Well Name: ROSE FEDERAL	Well Location: T5S / R25E / SEC 20 / SWNW /	County or Parish/State: CHAVES / NM
Well Number: 15	Type of Well: CONVENTIONAL GAS WELL	Allottee or Tribe Name:
Lease Number: NMNM36408	Unit or CA Name:	Unit or CA Number:
US Well Number: 3000563404	Well Status: Gas Well Shut In	Operator: SOLIS PARTNERS LLC

Notice of Intent

Type of Action: Plug and Abandonment

**Rose Federal 15
30-005-63404
Solis Partners, LLC
February 9, 2022
Conditions of Approval**

PROPOSED PLUG ABANDON
API # 30-005-63404

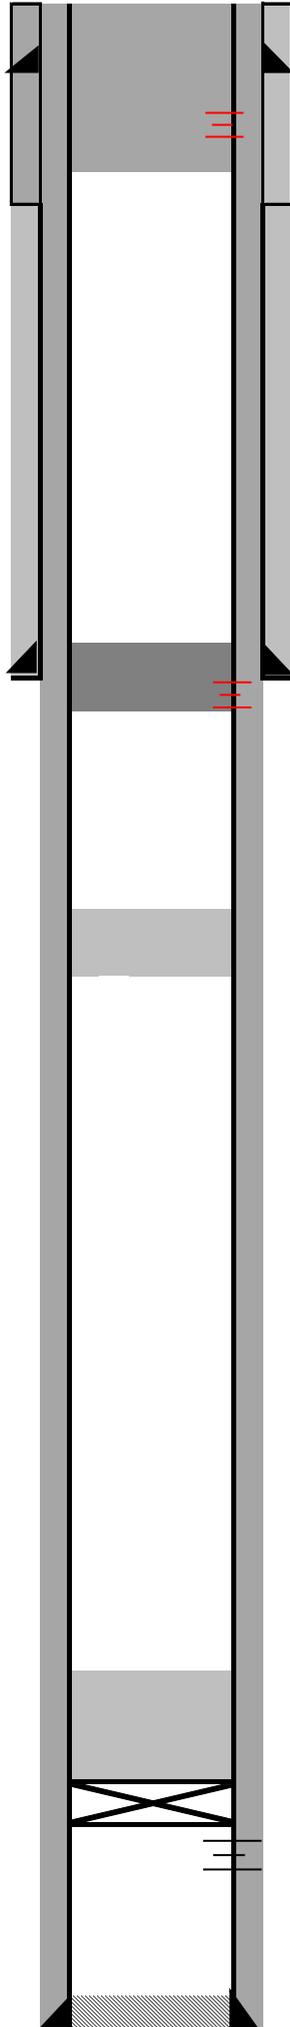
- 1. Operator shall place CIBP at 3,600' (50'-100' above top most perf) and places 25 sx of Class C cement on top as proposed. WOC and TAG.**
- 2. Operator perf at 2,100' and squeeze cement to 1,980' as proposed. WOC and TAG.**
- 3. Operator perf at 975' and squeeze cement to 875' as proposed to isolate the 9-5/8'' shoe. WOC and TAG.**
- 4. Operator shall perf at 100' and squeeze cement to surface.**
- 5. See Attached for general plugging stipulations.**
